PITT-08-19-011

**Re: Sunoco Pipeline LP – Pennsylvania Pipeline Project (Mariner East II)
Chapter 105 Permit No. E15-862 – Major Modification
REVISED Modification Request-Installation Method Change at PA Turnpike/0280 HDD
Upper Uwchlan Township, Chester County, PA**

**Applicable 102 Drawings
(E&S and Restoration)**

DATE:	2/6/17
PROJECT NO.:	112C05958
DESIGNED BY:	JB
DRAWN BY:	BH
CHECKED BY:	RS
COPYRIGHT:	TETRA TECH INC.
ES-6.24	
SHEET 6.24 OF 99

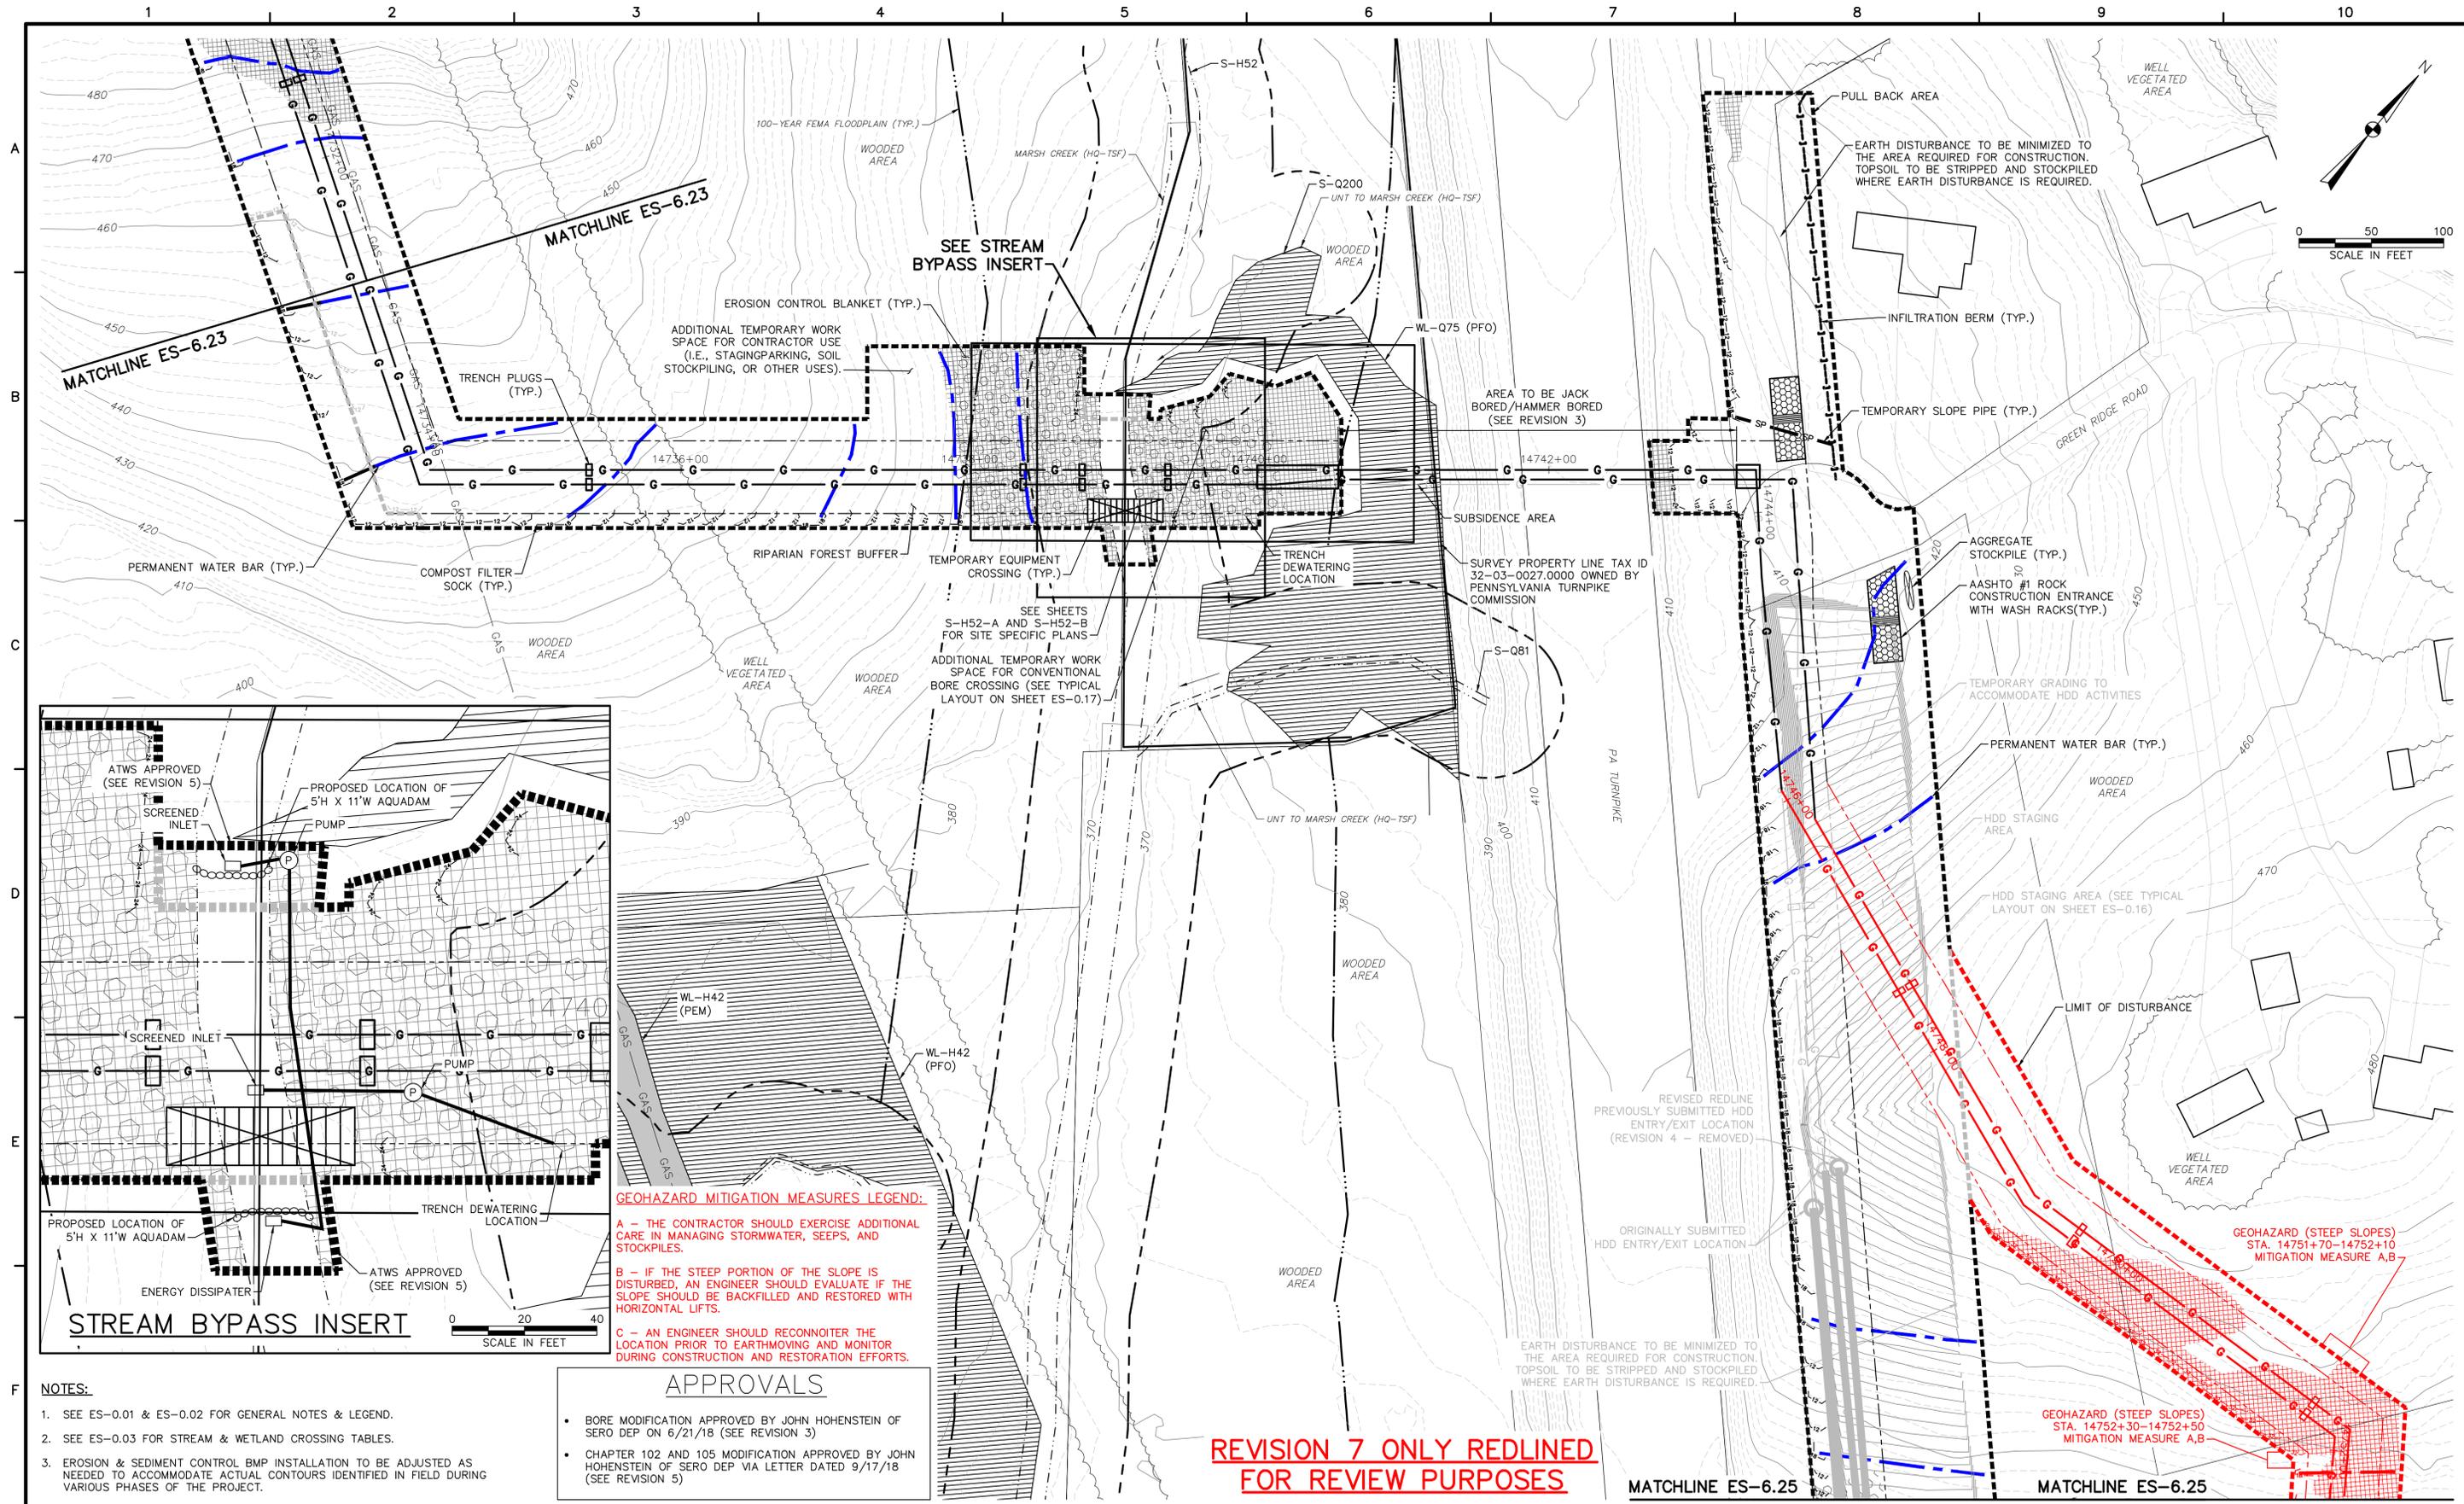
REVISIONS			
NO.	BY	DATE	REMARKS
1	RS	3/28/17	INCORPORATED THE SPECIAL CONDITIONS SET FORTH IN DEP'S CHAPTER 102 AND CHAPTER 105 PERMITS
2	RS	5/25/17	DRAWINGS PROVIDED TO FIELD
3	RS	3/5/18	BORE METHOD REVISION
4	RS	6/26/18	HDD AND CENTERLINE MODIFICATION
5	RS	8/3/18	ATWS ADDED FOR STREAM BYPASS INSERT
6	RS	12/17/18	PROPERTY LINE AND SUBSIDENCE ADDED
7	RS	3/12/19	16" AND 20" RE-ROUTE

DATE:	2/6/17
PROJECT NO.:	112C05958
DESIGNED BY:	JB
DRAWN BY:	BH
CHECKED BY:	RS
COPYRIGHT:	TETRA TECH INC.
ES-6.25	
SHEET 6.25 OF 99

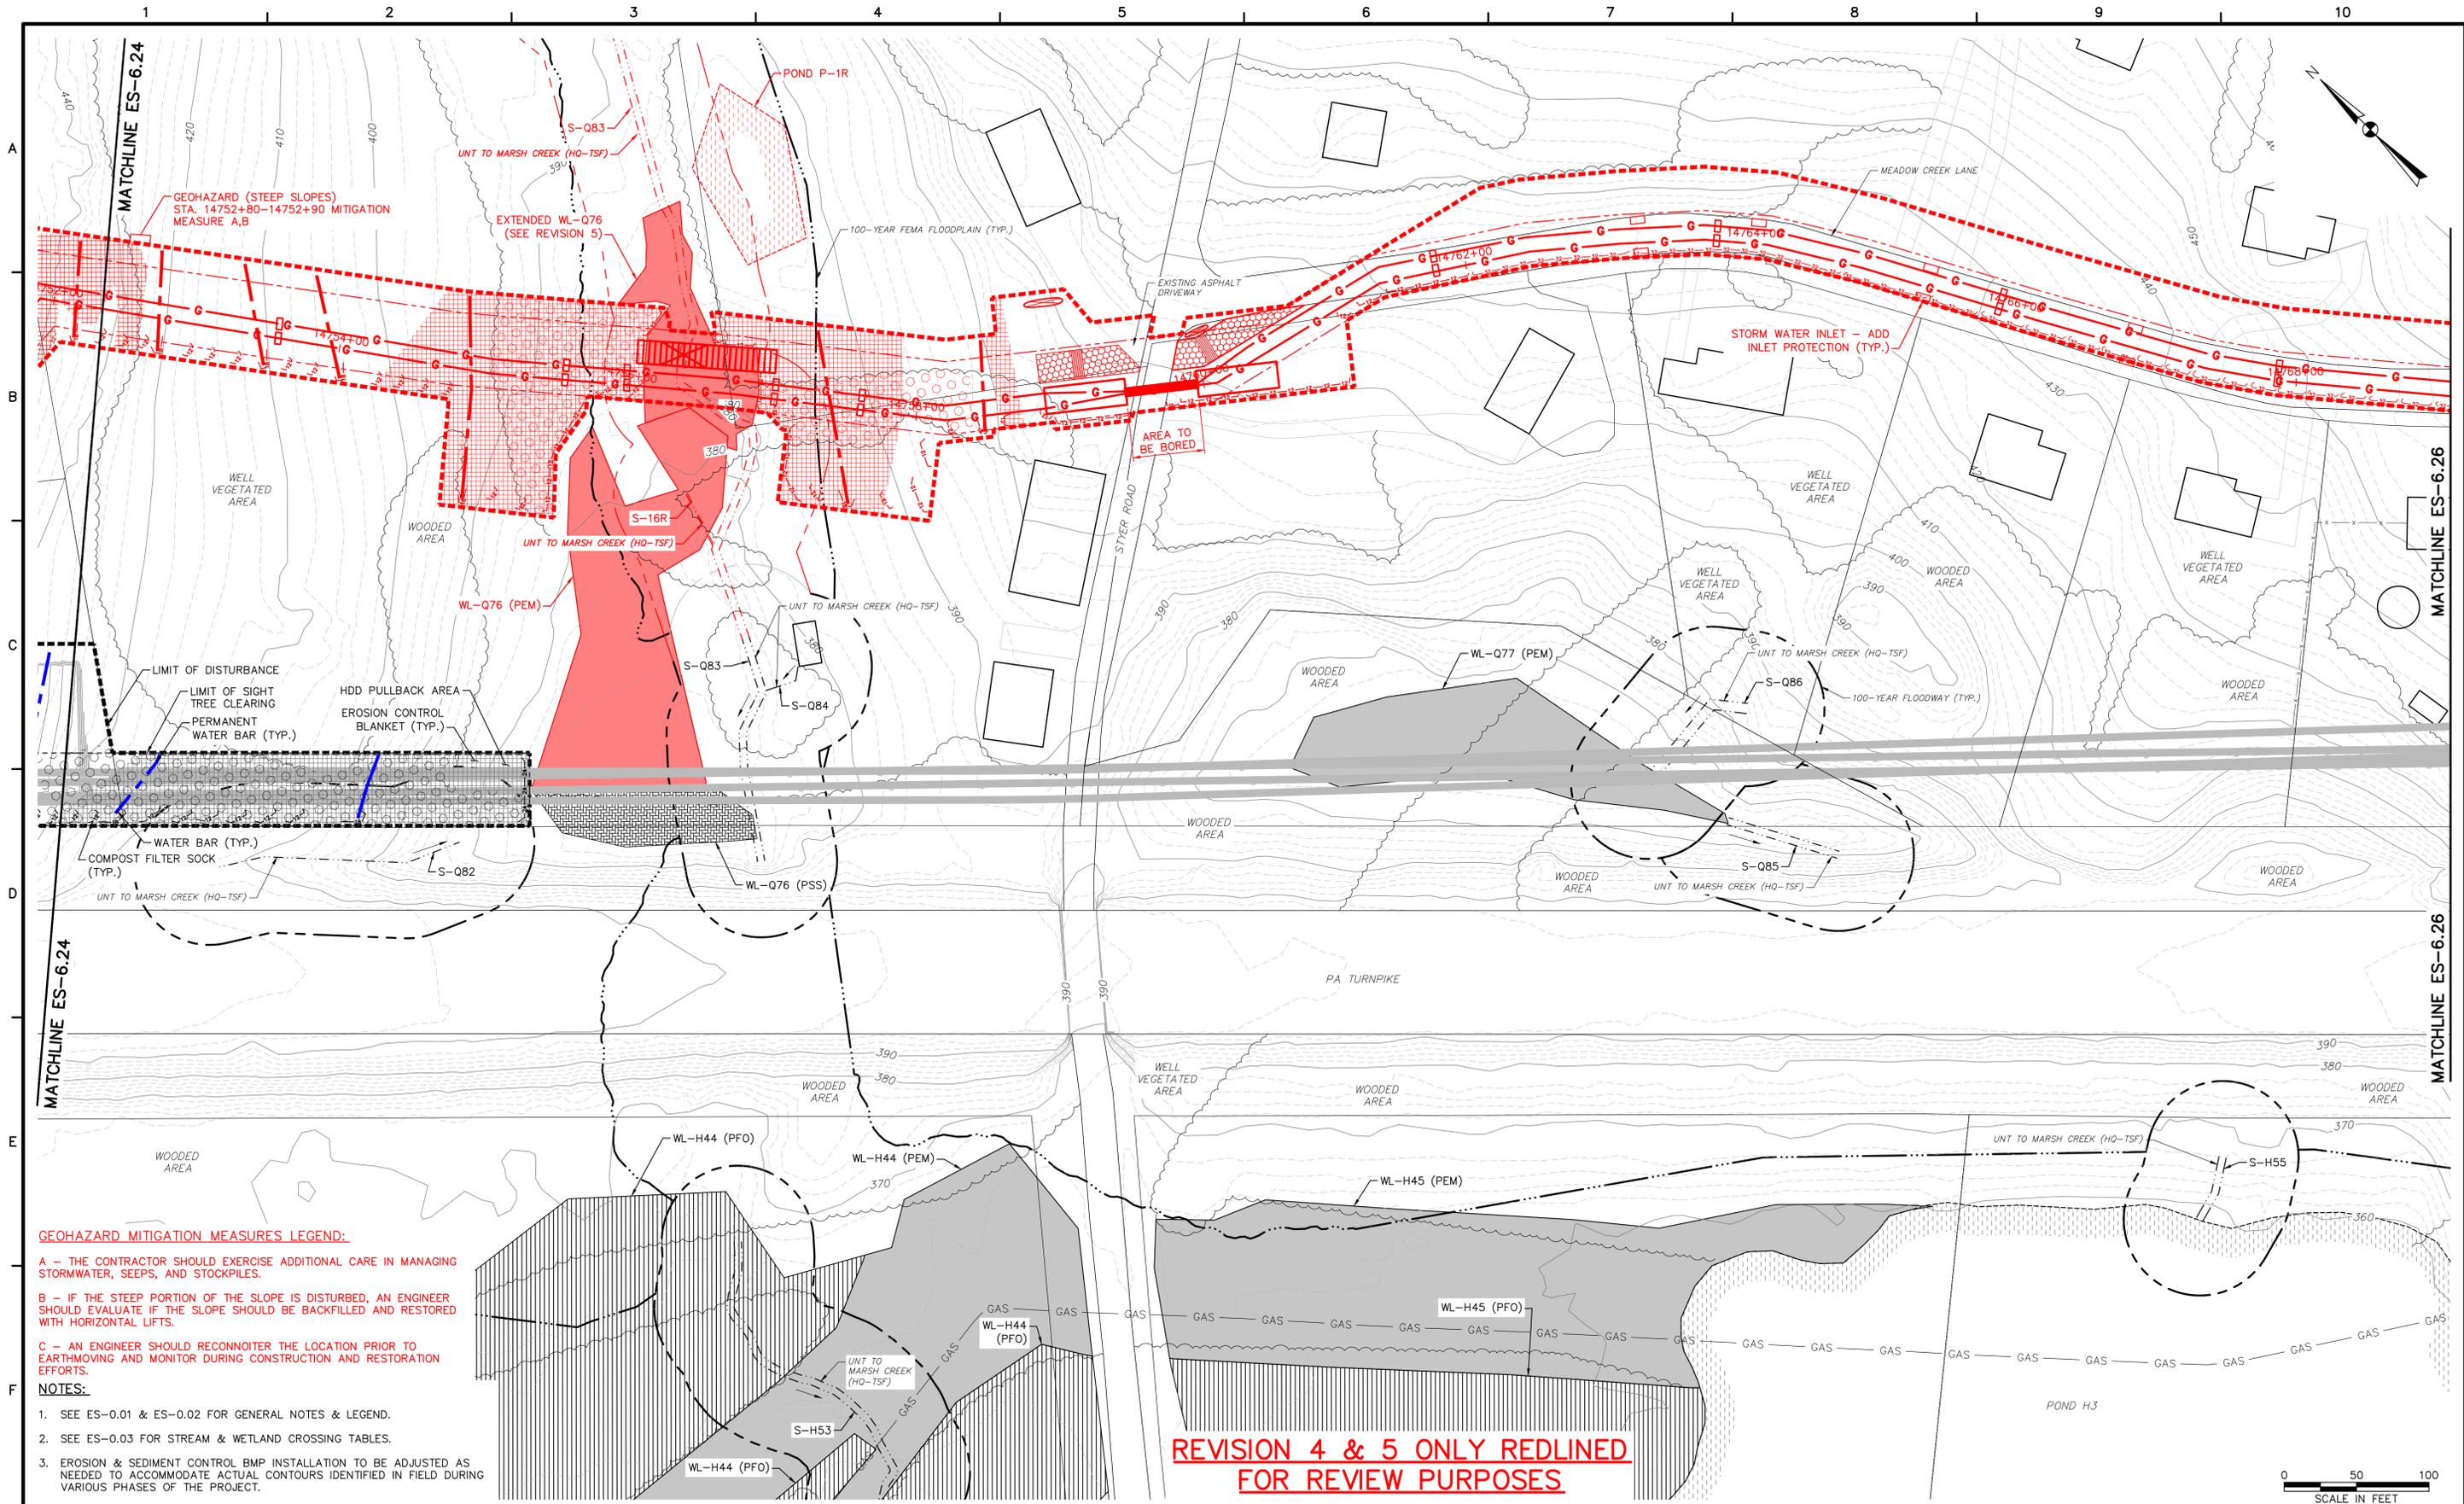
NO.		BY	DATE	REVISIONS	REMARKS
1	RS		3/28/17	INCORPORATED THE SPECIAL CONDITIONS SET FORTH IN DEP'S CHAPTER 102 AND CHAPTER 105 PERMITS	
2	RS		5/25/17	DRAWINGS PROVIDED TO FIELD	
3	RS		6/26/18	HDD MODIFICATION	
4	RS		3/12/19	16" AND 20" RE-ROUTE	
5	RS		7/30/19	EXTENDED WETLAND WL-Q76

DATE:	2/6/17
PROJECT NO.:	112C05958
DRAWN BY:	JB
CHECKED BY:	BH
COPYRIGHT TETRA TECH INC.	
ES-6.26	
SHEET 6.26 OF 99

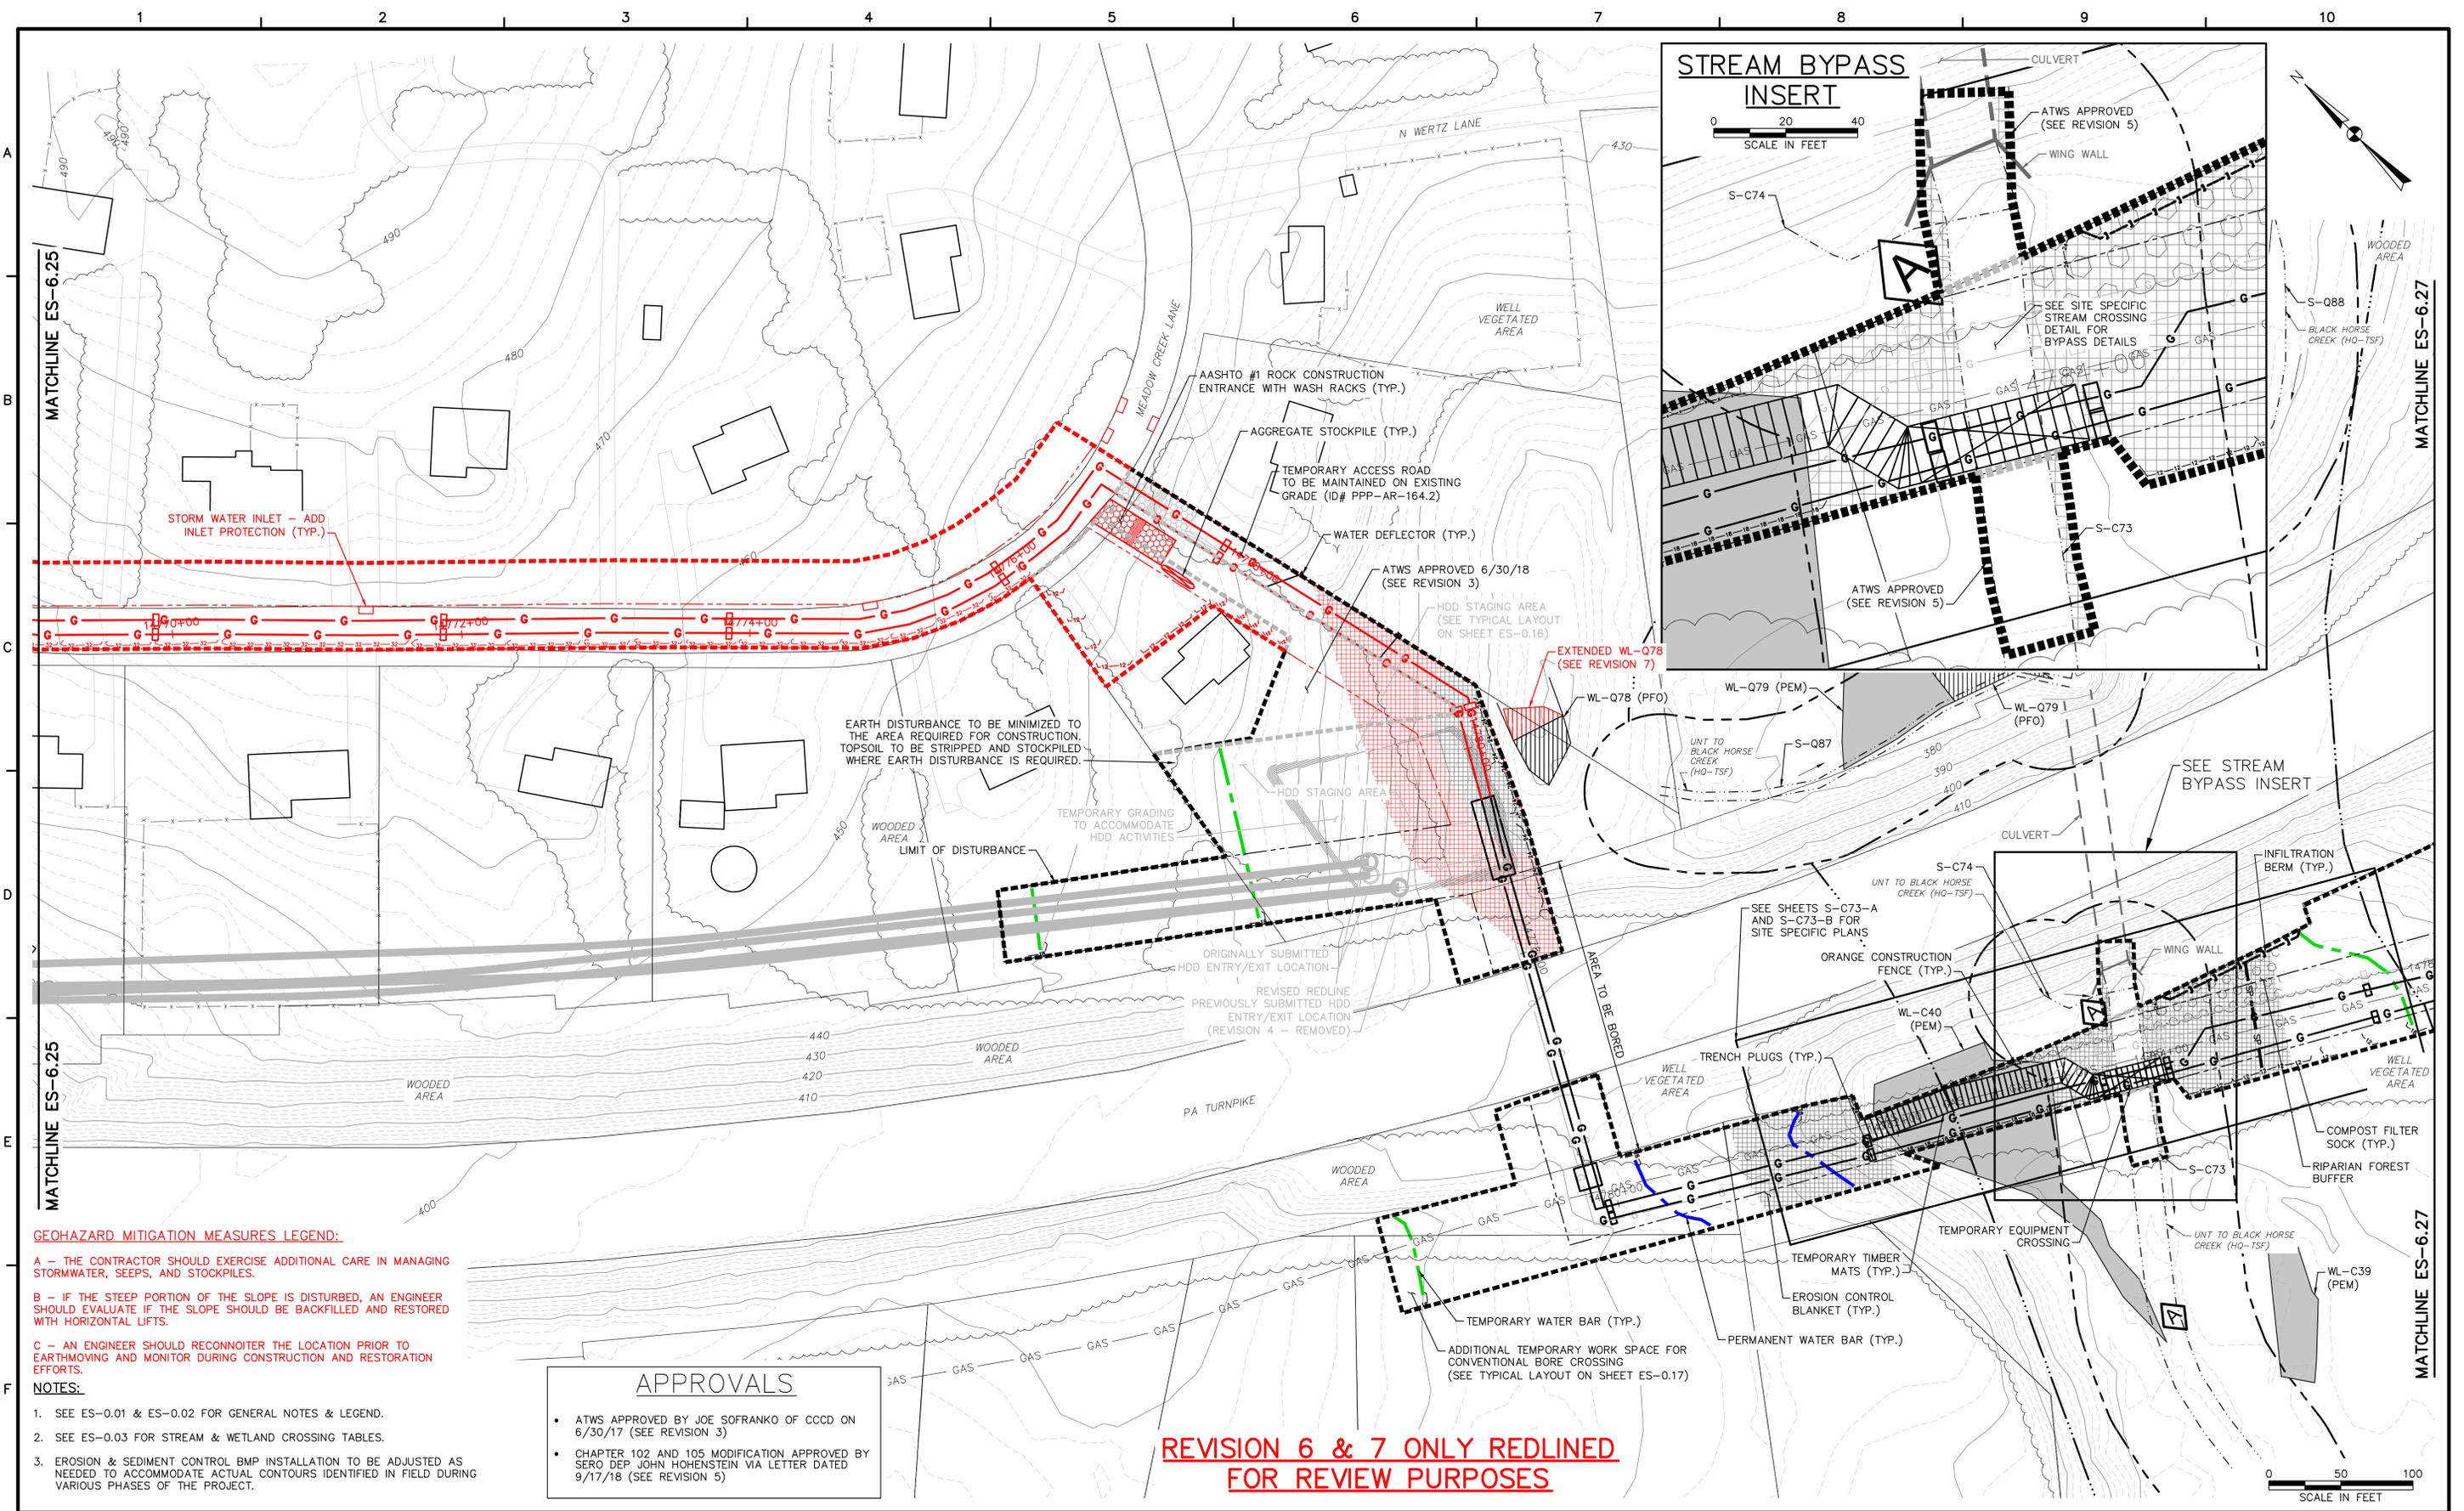
REVISIONS			
NO.	BY	DATE	REMARKS
1	RS	3/28/17	INCORPORATED THE SPECIAL CONDITIONS SET FORTH IN DEP'S CHAPTER 102 AND CHAPTER 105 PERMITS
2	RS	5/25/17	DRAWINGS PROVIDED TO FIELD
3	RS	6/28/17	ATWS ADDED
4	RS	6/26/18	HDD MODIFICATION
5	RS	7/26/18	ATWS MODIFICATION AND STREAM BYPASS INSERT
6	RS	3/12/19	16" AND 20" RE-ROUTE
7	RS	7/30/19	EXTENDED WETLAND WL-Q78
